REV.  
D

AS3253™

RATIONALE

BOLT, MACHINE - DOUBLE HEXAGON EXTENDED WASHER HEAD, DRILLED, PD SHANK, SILVER PLATED, NICKEL ALLOY, UNS N07718, 185 KSI MIN, .3750-24 UNJF-3A

FIGURE 1 - BOLT

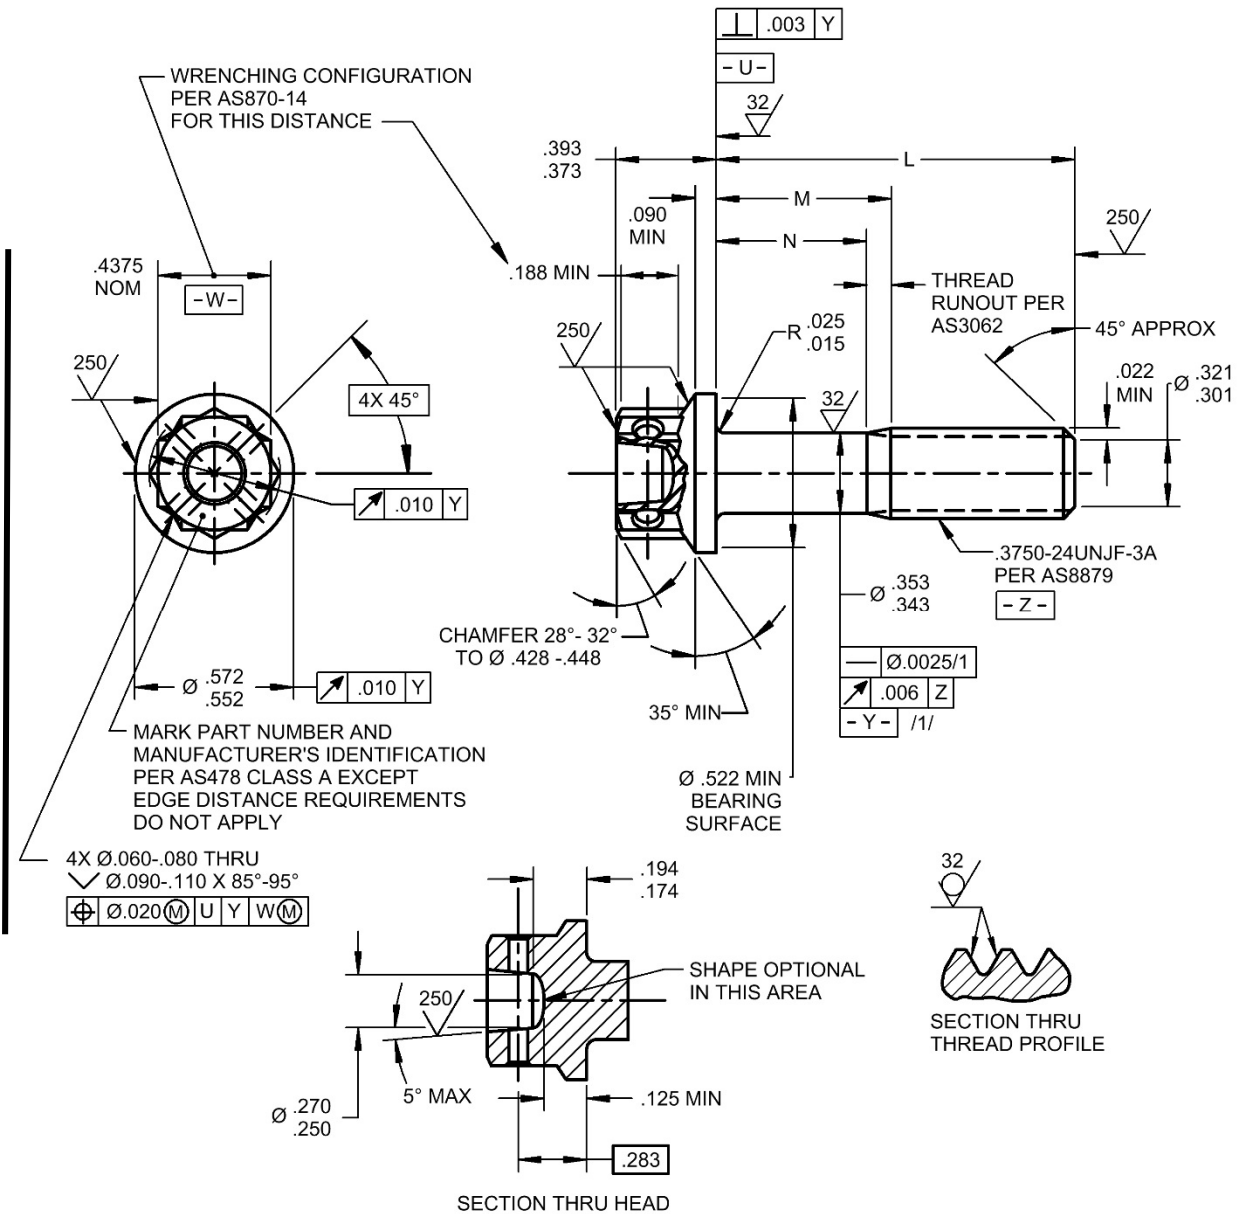
REVISE LEAD END CHAMFER REQUIREMENT TO CONFORM TO AS1132, REVISE RUNOUT REQUIREMENTS ON BOLT TO CONFORM TO CURRENT PRACTICE (AS1132), ADD TERTIARY DATUM TO THE POSITION REQUIREMENT ON THE DRILLED HOLES, UPDATE REFERENCES, EDITORIAL CHANGES FOR CONFORMANCE TO ANSI Y14.5M-1982, ADD NEW NOTE FOR THE DISPOSITION OF EXISTING INVENTORY, GENERAL EDITORIAL CHANGES.
